UNITED STATES PATENT AND TRADEMARK OFFICE

APPLICATION NO.	FILING DATE	FIRST NAMED INVENTOR	ATTORNEY DOCKET NO.	CONFIRMATION NO.
10/670,439	09/25/2003	Douglass L. Blanding	86705NAB	5540

Office Action Summary

DETAILED ACTION

FIG. 1

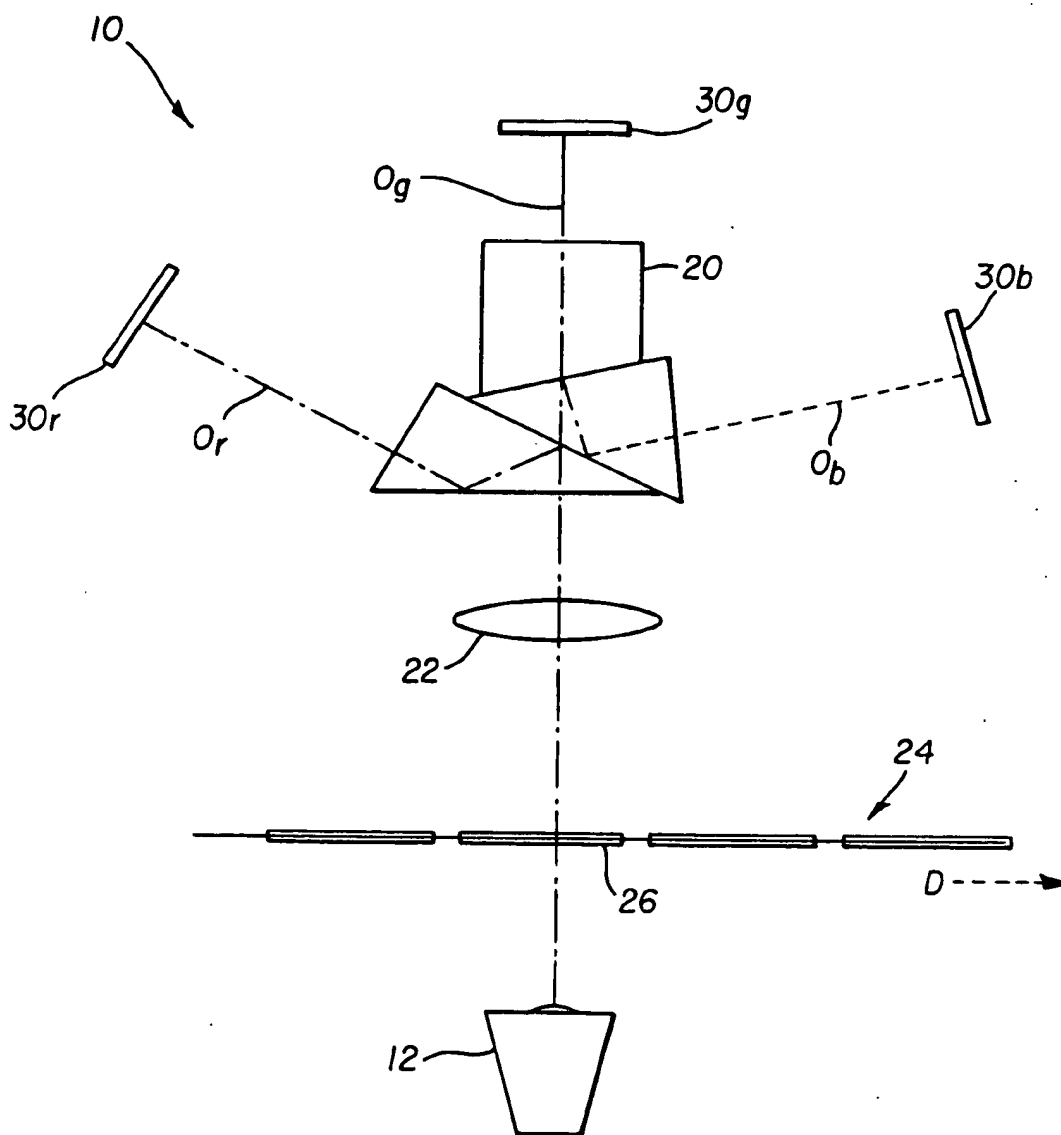
Figure 1 should be designated by a legend such as --Prior Art-- because only that which is old is illustrated. See MPEP § 608.02(g). Corrected drawings in compliance with 37 CFR 1.121(d) are required in reply to the Office action to avoid abandonment of the application. The replacement sheet(s) should be labeled "Replacement Sheet" in the page header (as per 37 CFR 1.84(c)) so as not to obstruct any portion of the drawing figures. If the changes are not accepted by the examiner, the applicant will be notified and informed of any required corrective action in the next Office action. The objection to the drawings will not be held in abeyance.

Acceptable
per
1/27/06
